STAFF REPORT 01-22-2020 REGULAR MEETING

**APPLICATION NUMBER:** 19-6597 **ADDRESS:** 2415 BURNS AVENUE

SCOPE: GENERAL REHABILITATION AND EXTERIOR ALTERATION OF CARRIAGE HOUSE

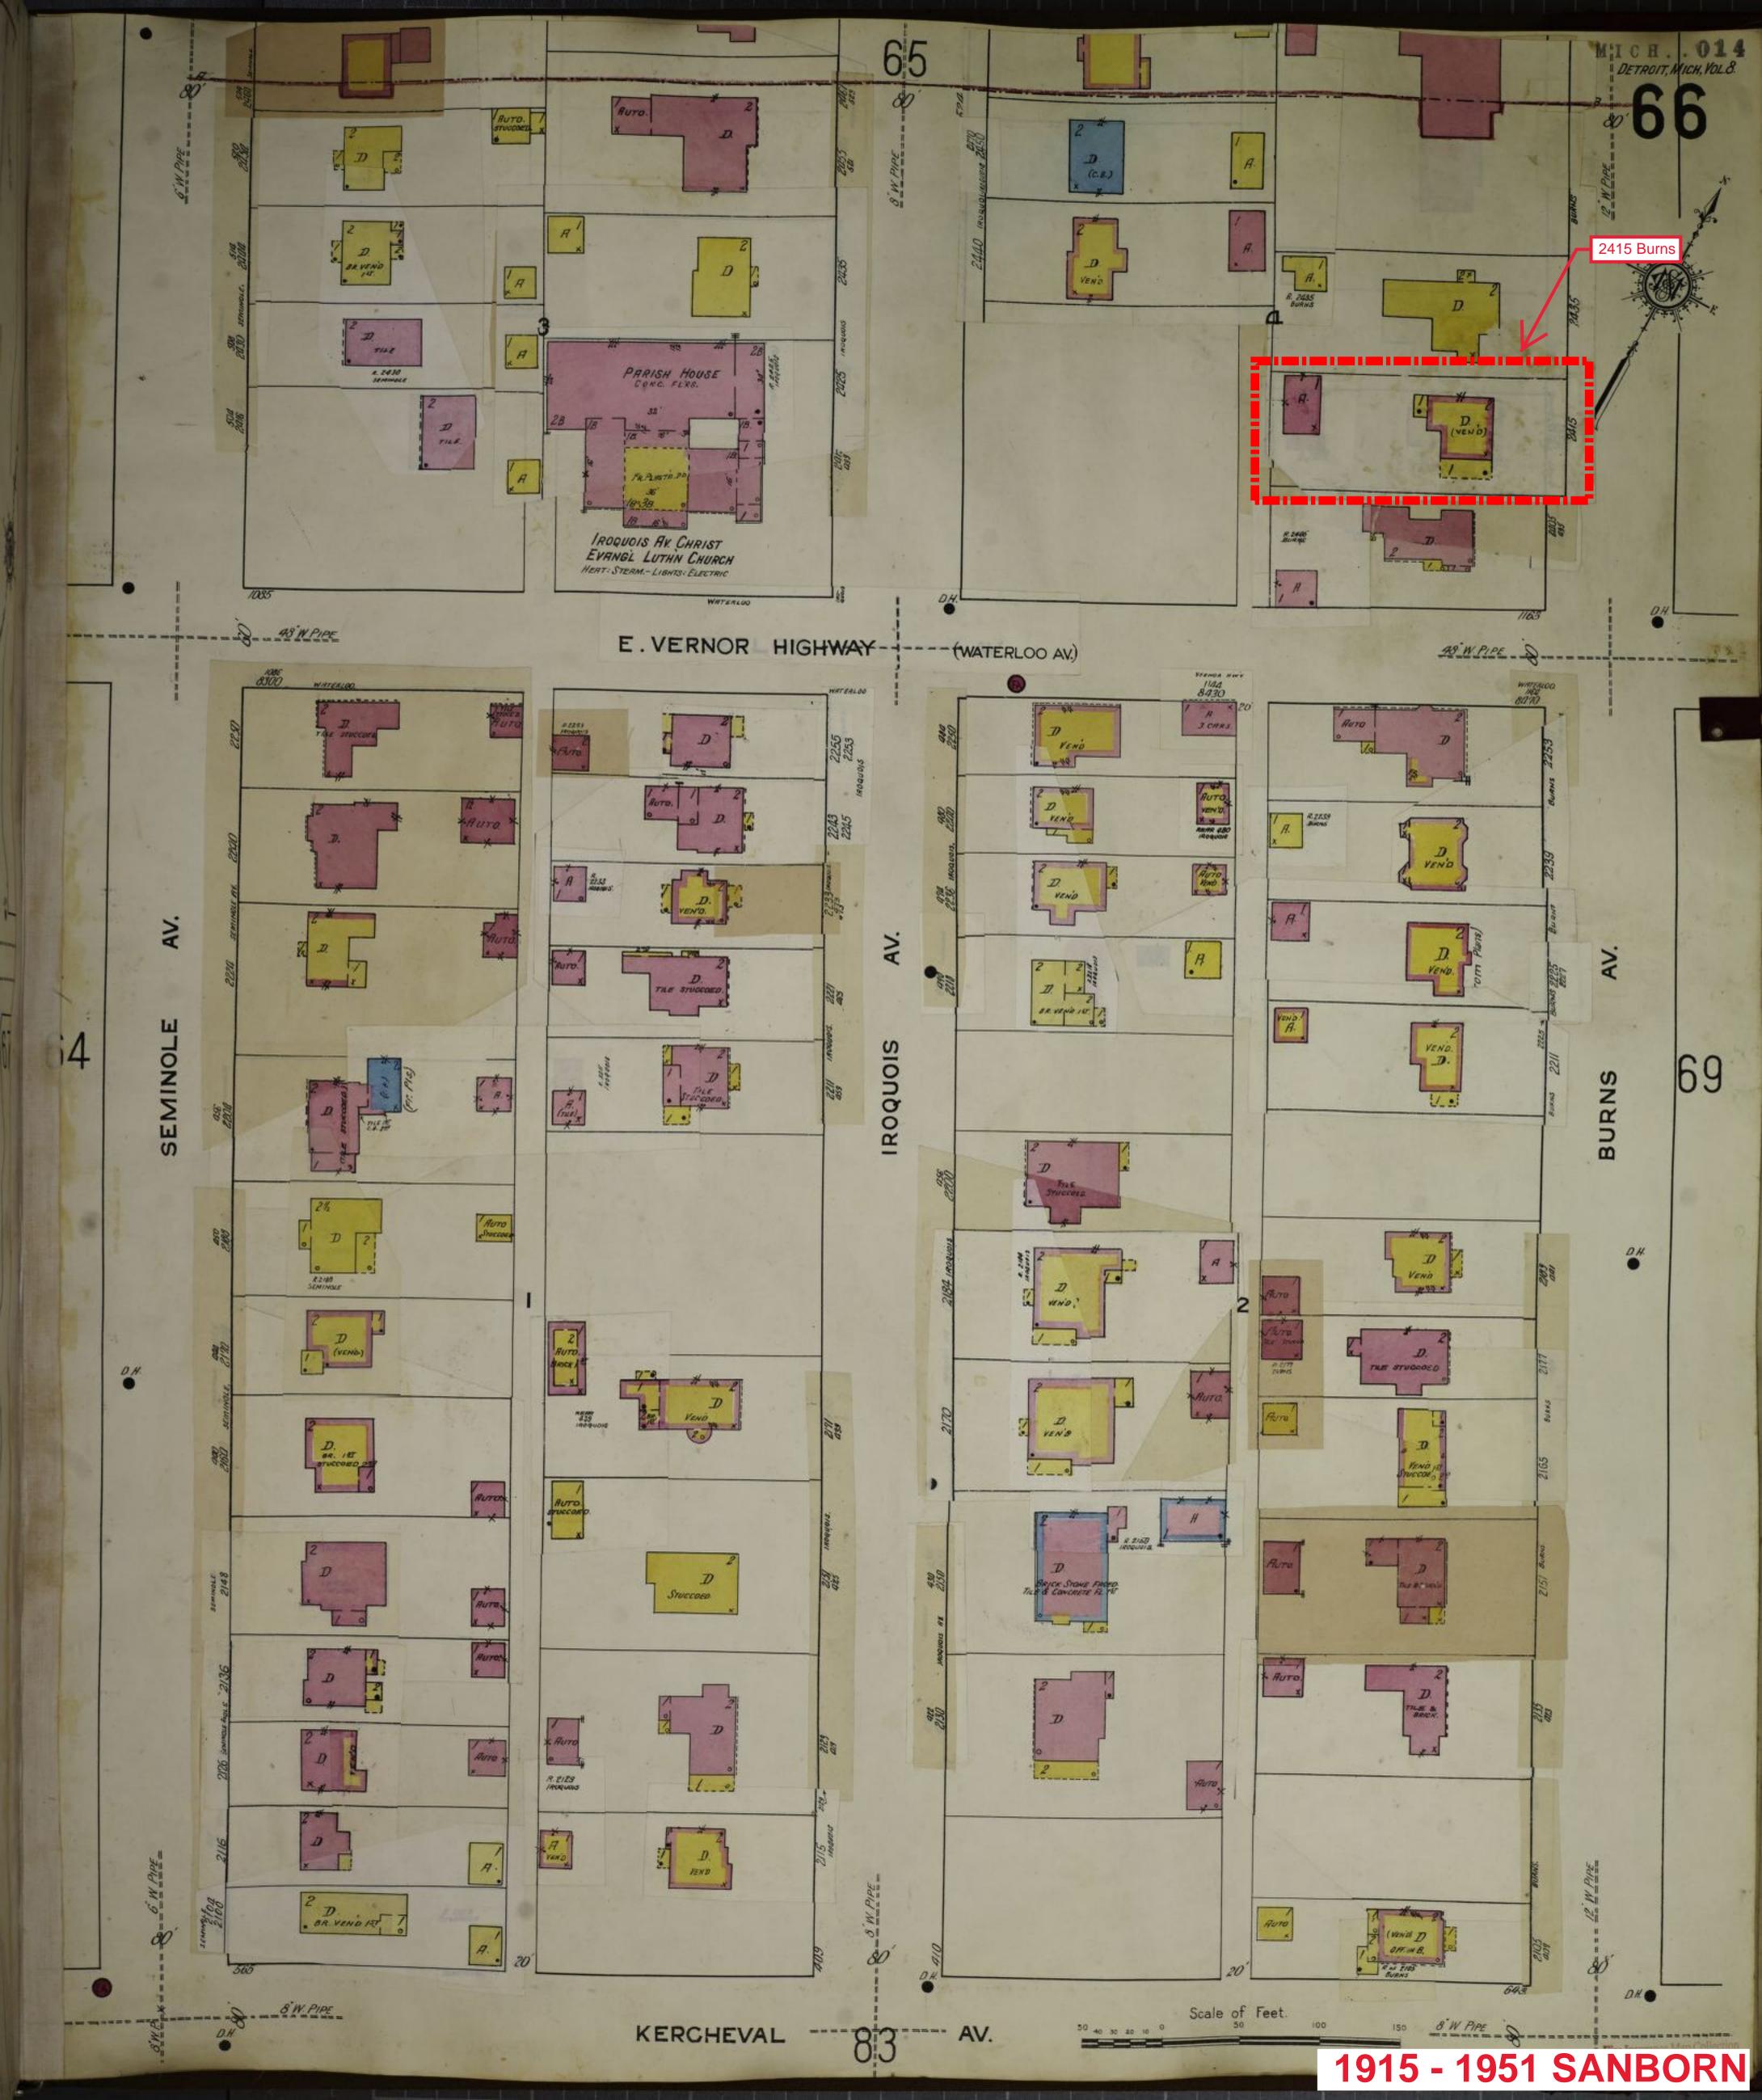
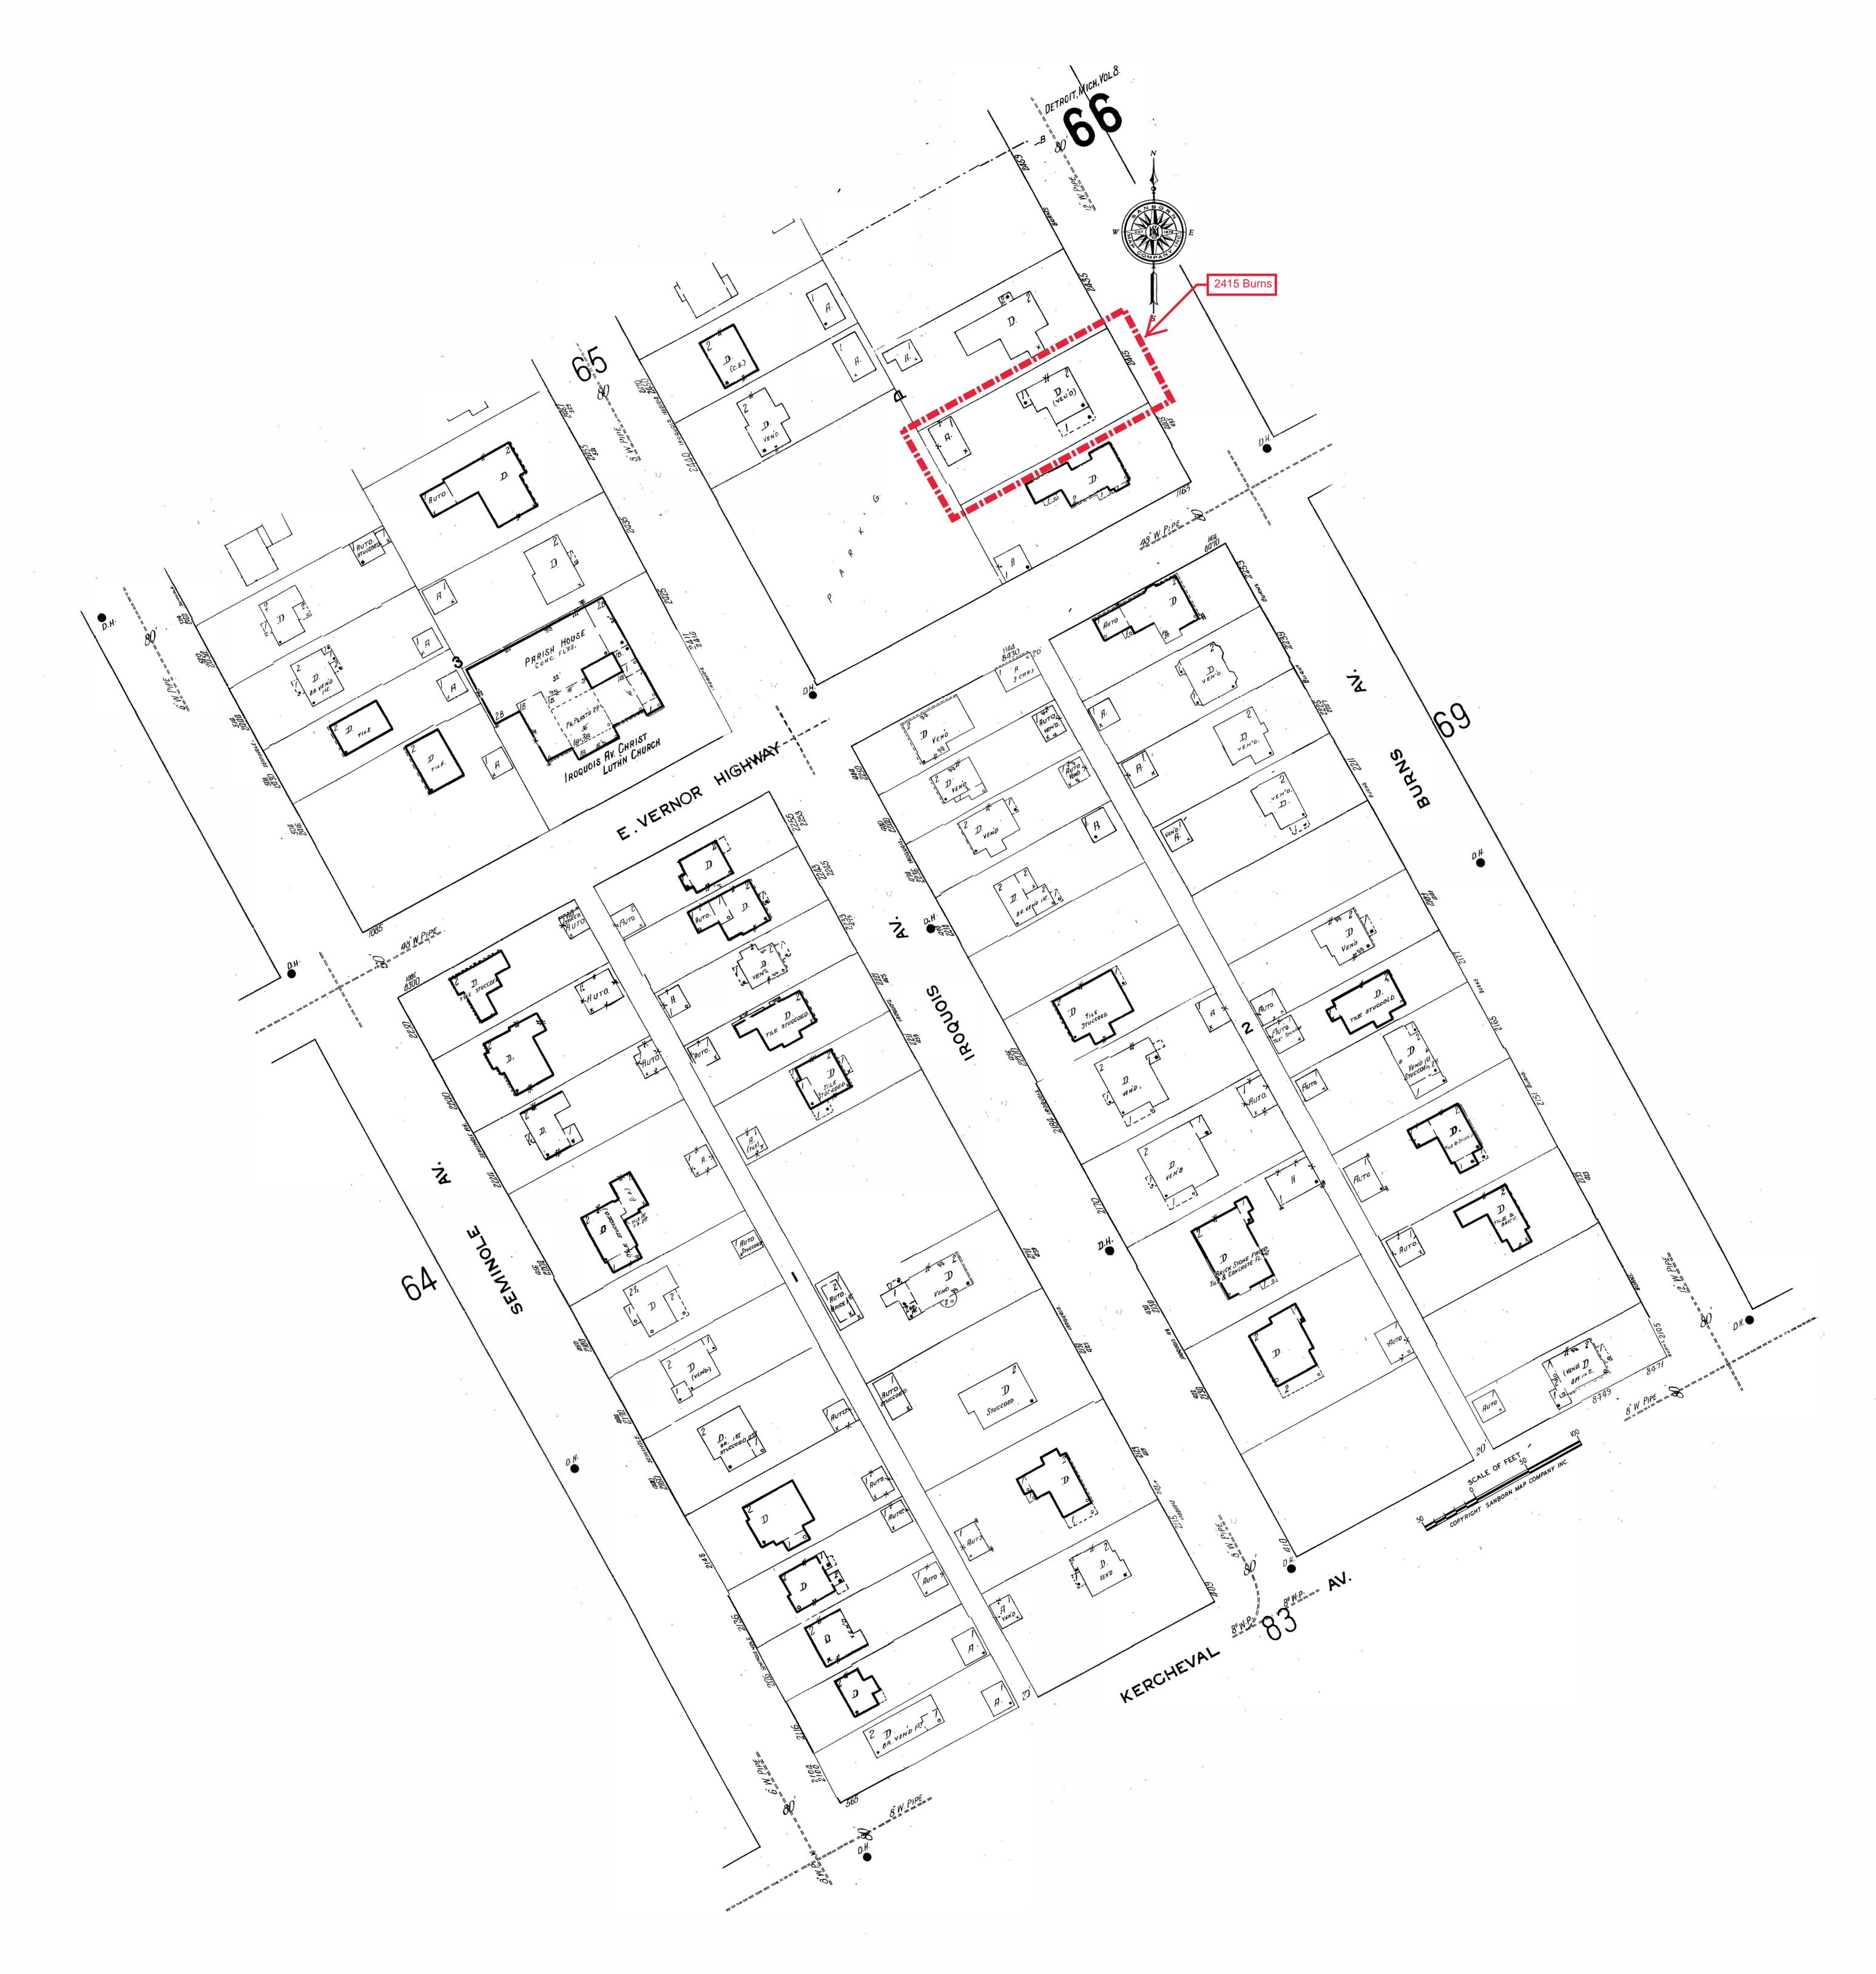
- Although it is unknown as to whether the garage was constructed with the house, it is of historic age.
- Originally constructed as an automobile garage, the (3) existing openings in number and proportion –
  are character-defining features of the historic structure. Modifying the proportion and number of
  openings will affect the historic integrity of the property.

**SECOND FLOOR - NEW WORK**

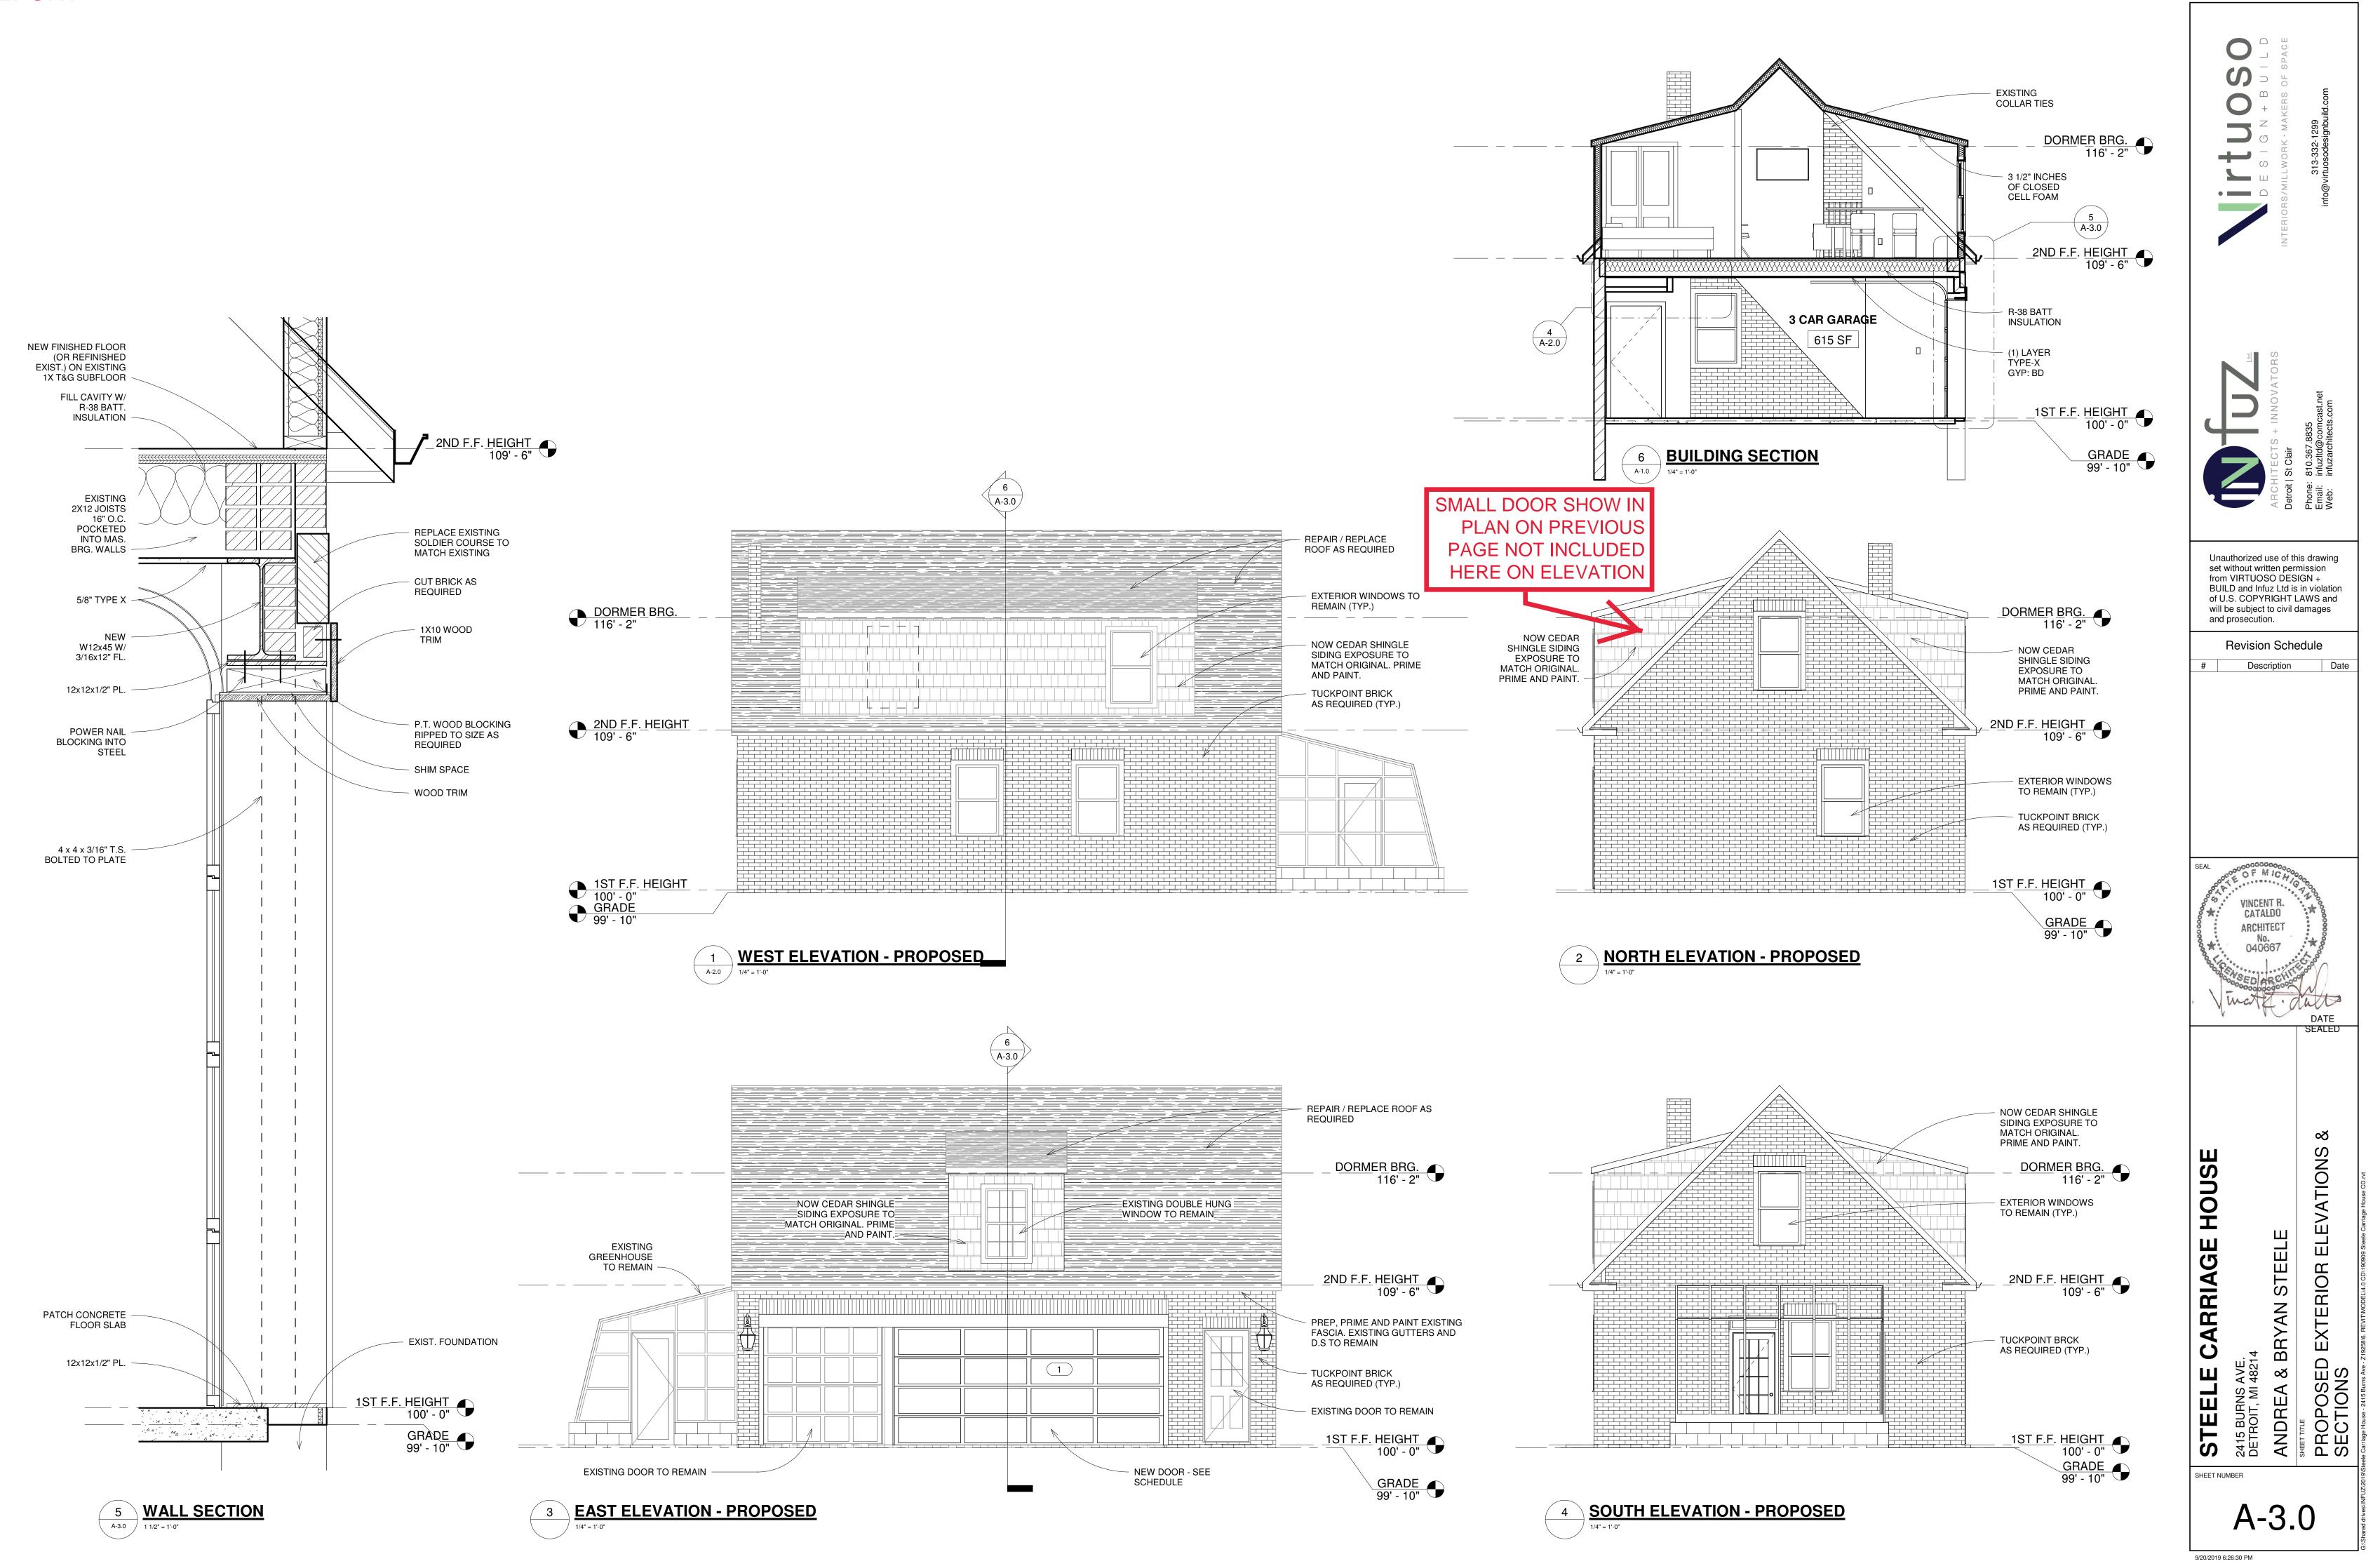
- There are discrepancies within the drawing set including:
  - Second Floor Demo Plan (Drawing 2, Sheet A-1.0) does not match the footprint of the Second Floor New Work Plan (Drawing 1, Sheet A-2.0). The New Work Plan suggests that modifications to the massing of the second floor are proposed, however, the elevations do not reflect a change in massing.

- O A small door (1'-6" x 2'-10") is shown at the south side of the Dining Alcove in the Second Floor New Work Plan (Drawing 1, Sheet A-2.0) but isn't represented on the elevation (Drawing 4, Sheet A-3.0).
